Grave Creek Watershed Water Quality and Habitat Restoration Plan and Sediment Total Maximum Daily Loads

March 2005

ERRATA SHEET FOR THE GRAVE CREEK WATERSHED WATER QUALITY AND HABITAT RESTORATION PLAN AND SEDIMENT TOTAL MAXIMUM DAILY LOADS

Figure 2-1: Grave Creek Hydrograph for April 1, 1923 through June 30, 1924 (Data Missing from January through April 1, 1924).

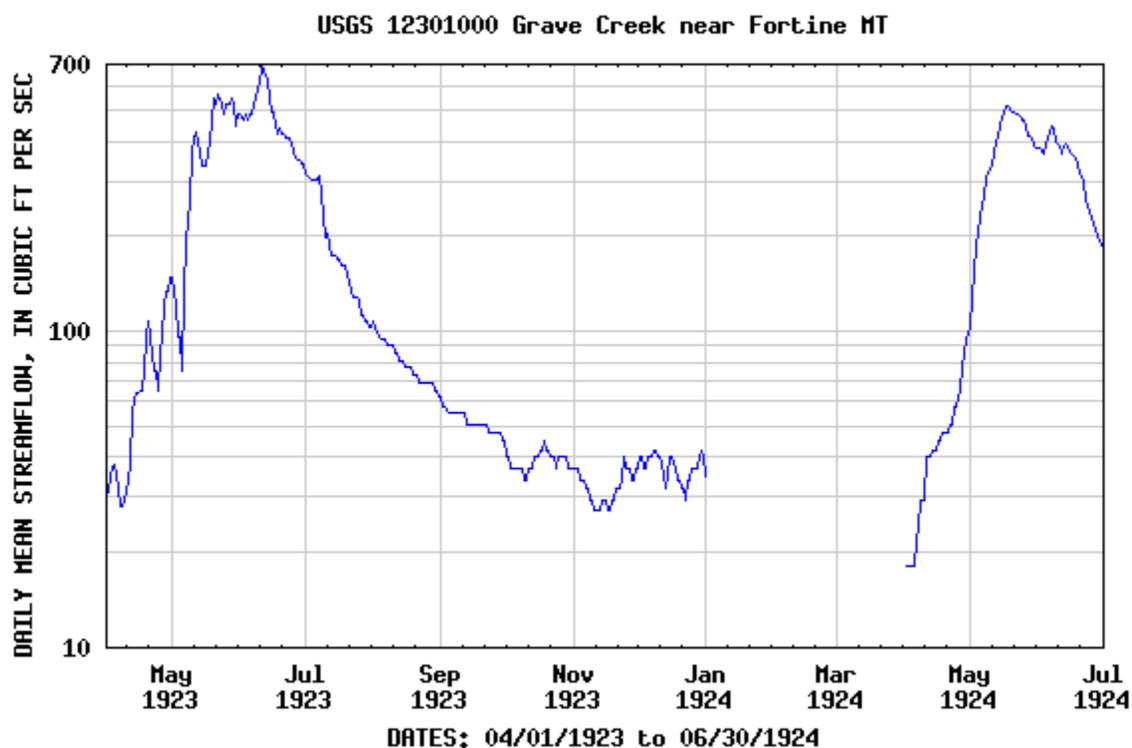
Comment 2-1: *Page 4, Figure 2-1* – Doesn't MT Fish, Wildlife, and Parks have some of this data?

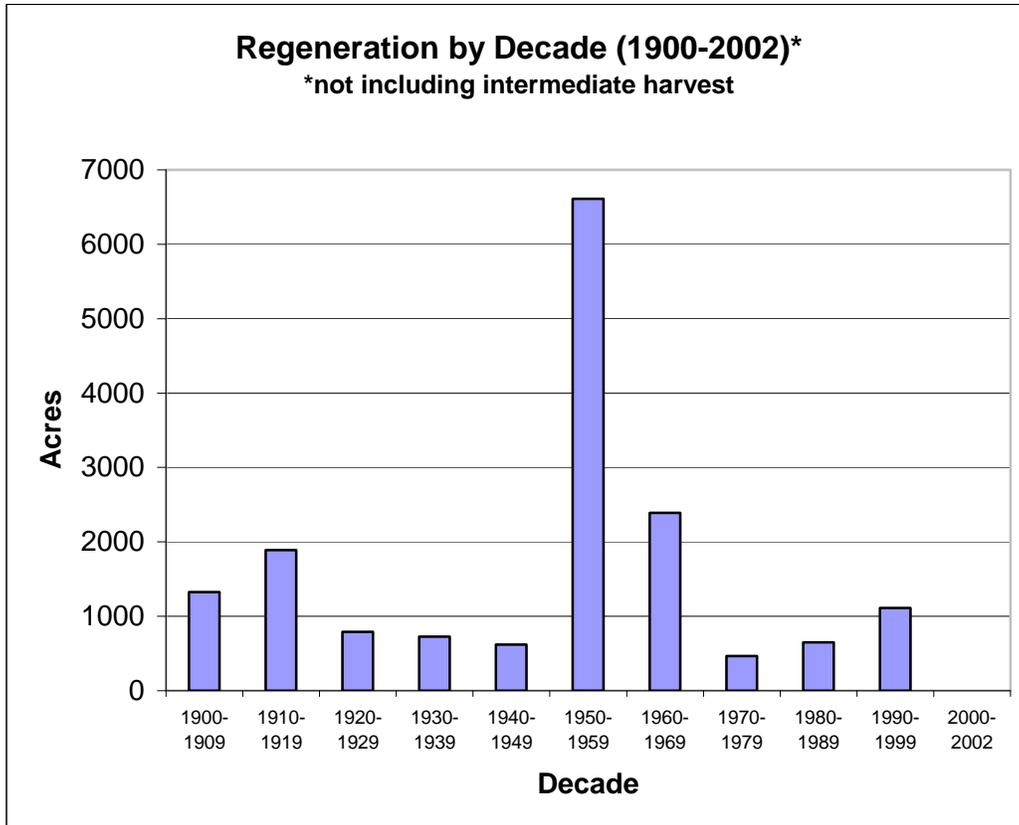
Comment 2-10: *Page 18, Figure 2-2* – “hi-grade logging” is an inflammatory, value-laden, and non-measurable term. Delete it. In our October 6th meeting we asked to be consulted to verify these figures. That has not occurred.

Response to Comment 2-10: The term “hi-grade logging” has been removed, although it is interesting to note that the term was obtained from within a publication from the agency providing this comment (USFS, 2002). Identifying the precise historical acreage details is not considered as important as identifying the overall occurrence of such activities as utilized within this document, which is sufficiently accomplished by Figure 2-2. A note is added to the document here and other places pointing out that future detailed analysis may result in further refinement of some of the land use values linked to timber harvest levels.
